MARIELLA ESTATES JSP26-09

Public hearing at the request of Braciolo Brothers, Inc. for Preliminary Site Plan with Site Condominium, Woodland Permit and Storm Water Management Plan. The subject property is zoned R-1 with a Planned Rezoning Overlay (PRO). The applicant is proposing to develop 10 single family lots and associated roads and utilities.

PLAN REVIEW CENTER REPORT

Revised Preliminary and Final Site Plan

BRADCOE BROTHERS, LLC
MARIELLA ESTATES
FINAL SITE PLAN
STORM SEWER PLAN & PROFILE 2

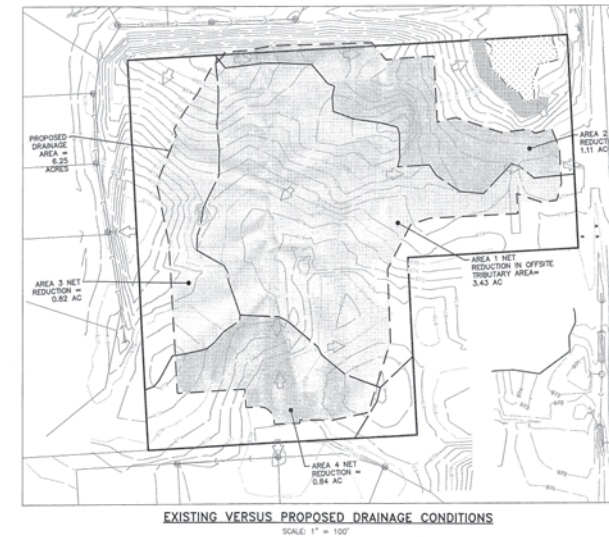
1. Stormwater shall not cross property lines, adjust the storm sewer or provide swales to ensure that stormwater does not cross property lines. Grading near lots 5,6, 7, 8, 9 and 10 must be adjusted. The current grading may cause water to pool south of lot 9 near the homes south of the development. Revised grading plans should be provided with the next submittal.
2. Traffic signs in the Road Commission for Oakland County (RCOC) right-of-way will be installed by RCOC. A [Right-of-Way Permit](#) will be required from the City of Novi and Oakland County.
3. **Only at the time of the printed Stamping Set submittal**, provide the City's standard detail sheets for water main (5 sheets), sanitary sewer (3 sheets), storm sewer (2 sheets), paving (2 sheets). The most updated details can be found on the City's website under [Engineering Standards and Construction Details](#).

8. A minimum cover depth of 3 feet shall be maintained over all proposed storm sewer. Currently, a few pipe sections do not meet this standard. Grades shall be elevated, and minimum pipe slopes shall be used to maximize the cover depth. In situations where the minimum cover cannot be achieved, Class V pipe must be used with an absolute minimum **cover depth of 2 feet**. An explanation shall be provided where the cover depth cannot be provided.
